# Access Compliance Report

## Public Rights-of-Way

### (Curb Ramps)

Intersection ID: 48416	Main Street: YORK_CROSSING_DR	Cross Street: S_TRYON_ST	Location: NE
ADA ID: DB210AD7658A	Ramp Type: Perp	Initial Pass/Fail: Fail	Overall Compliance: No
Severity Score: 8.75			
Codes/Mitigation Info/Possible Solution		Field Measurements/Component Compliance

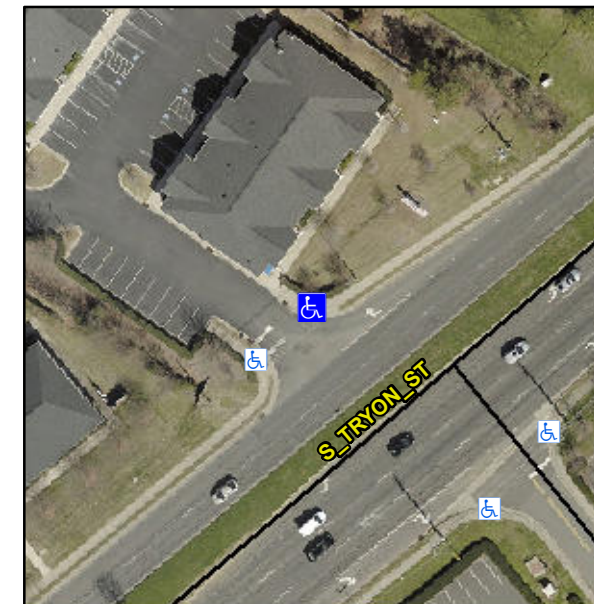
**Not Found, R304.5.1**

Compliance	Description	Data	Compliance	Description	Data
N/A	Ramp Length (in)	89.0	Yes	Ramp Slope (%)	6.6
No	Ramp Width (in)	46.0	Yes	Ramp XSlope (%)	1.8
N/A	Flare Type LT	N/A	N/A	Flare Type RT	N/A
N/A	Flare Slope LT (%)	N/A	N/A	Flare Slope RT (%)	N/A
N/A	Flare Traversable LT?	N/A	N/A	Flare Traversable RT?	N/A
N/A	Landing Length (in)	N/A	N/A	DWS Provided?	N/A
N/A	Landing Width (in)	N/A	N/A	DWS Contrast?	N/A
N/A	Landing Slope (%)	N/A	N/A	DWS Length (in)	N/A
N/A	Landing X Slope (%)	N/A	N/A	DWS Full Width?	N/A
N/A	Landing Curb? (Y/N)	N/A	N/A	DWS Offset (in)	N/A
N/A	Shared Landing?	N/A			
N/A	Gutter Ponding?	N/A	N/A	Gutter Slope (%)	N/A
N/A	Gutter Lip Ht (in)	N/A	N/A	Gutter X Slope (%)	N/A
N/A	Painted X Walk1?	Yes	N/A	Painted X Walk2?	N/A
	X Walk 1 Direction	To W		X Walk 2 Direction	N/A
N/A	X Walk 1 Width (in)	55.0	N/A	X Walk 2 Width (in)	N/A
	X Walk 1 Slope (%)	1.0		X Walk 2 Slope (%)	N/A
	X Walk 1 X Slope (%)	0.2		X Walk 2 X Slope (%)	N/A

**Remove & Replace Entire Ramp.**
